NUCLEAR POWER SYSTEMS  
COMBUSTION ENGINEERING, INC.  
COMPONENTS ENGINEERING  
Chattanooga, Tennessee

DALISADES AUXILIARY FEEDWATER  
NOZZLE GRINDOUTS

Subject: Palisades Steam Generator Loose Parts

**SUBJECT: AUXILIARY FEEDWATER SPARGER REPAIR**

AUX FEEDWATER  
NOZZLE RADIUS  
GRINDING

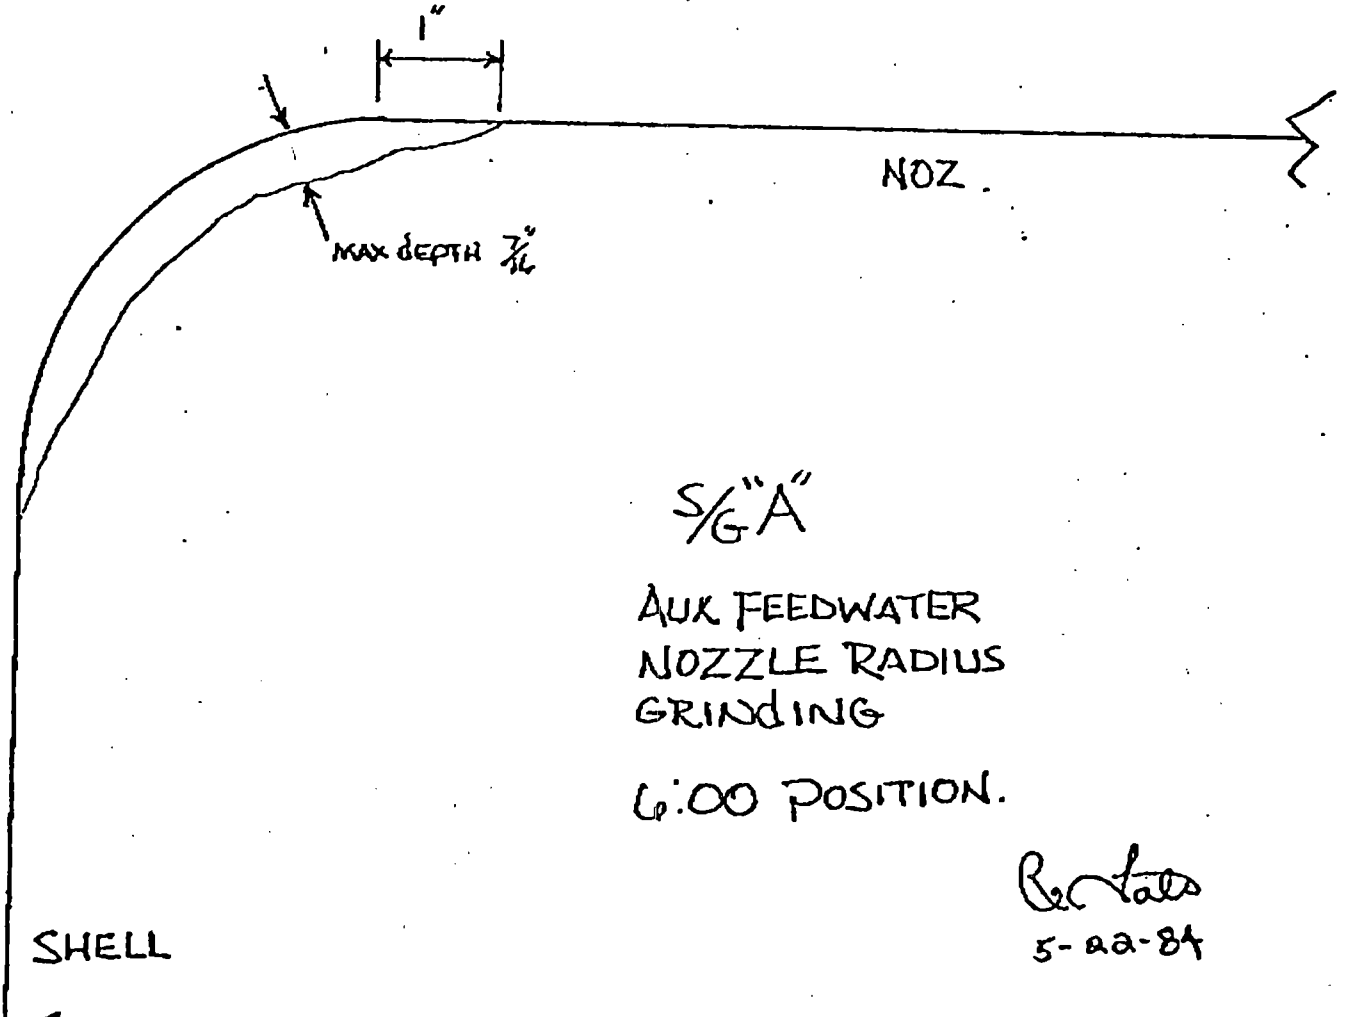
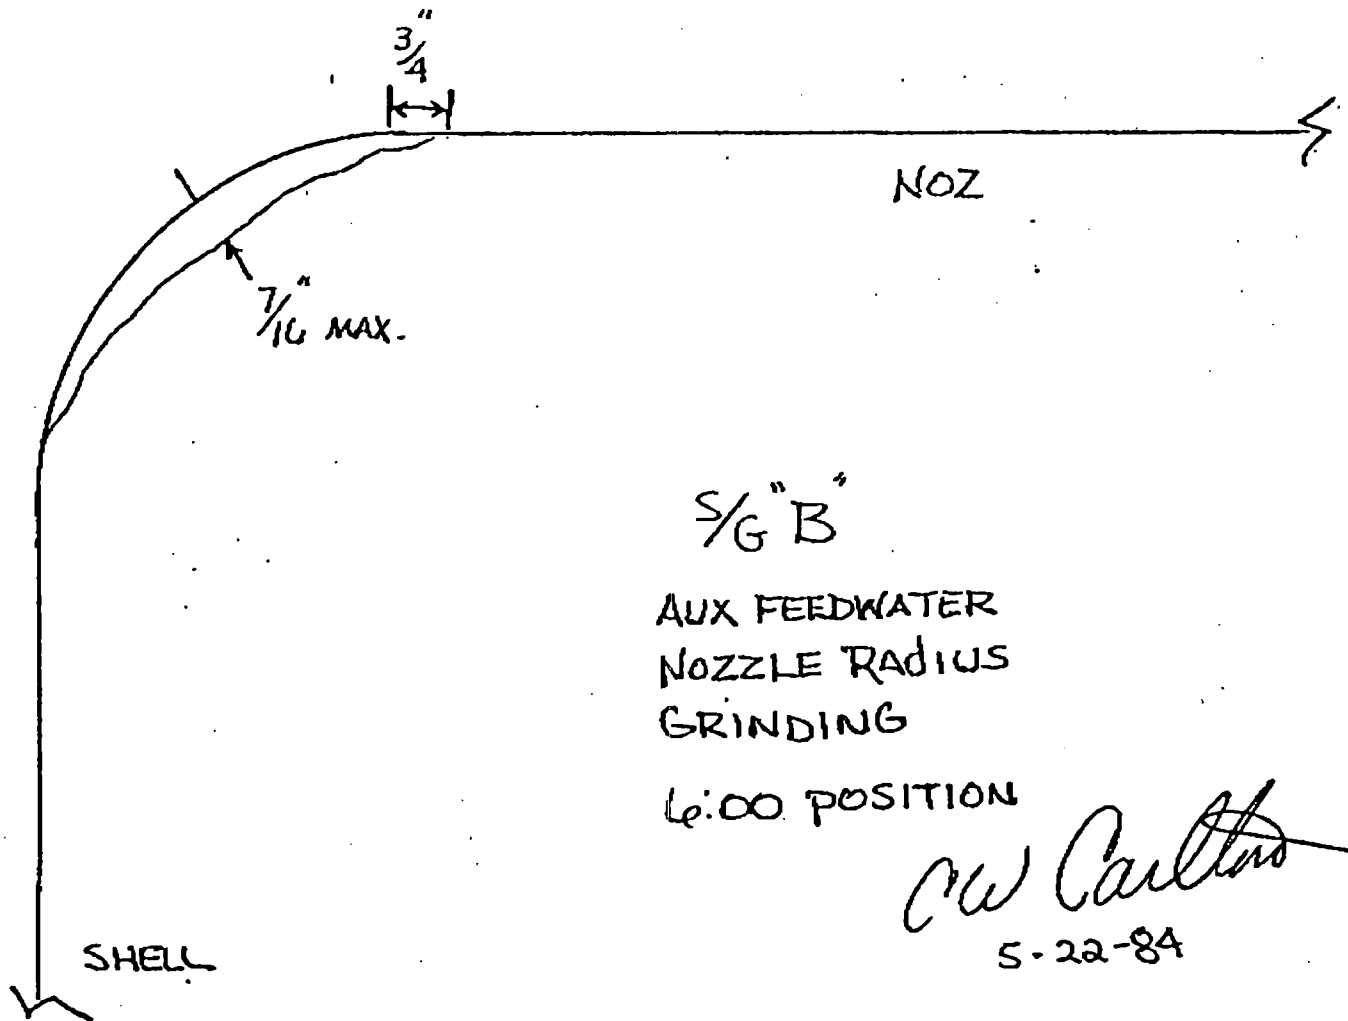
Revised  
5-22-84

7/16" MAX.
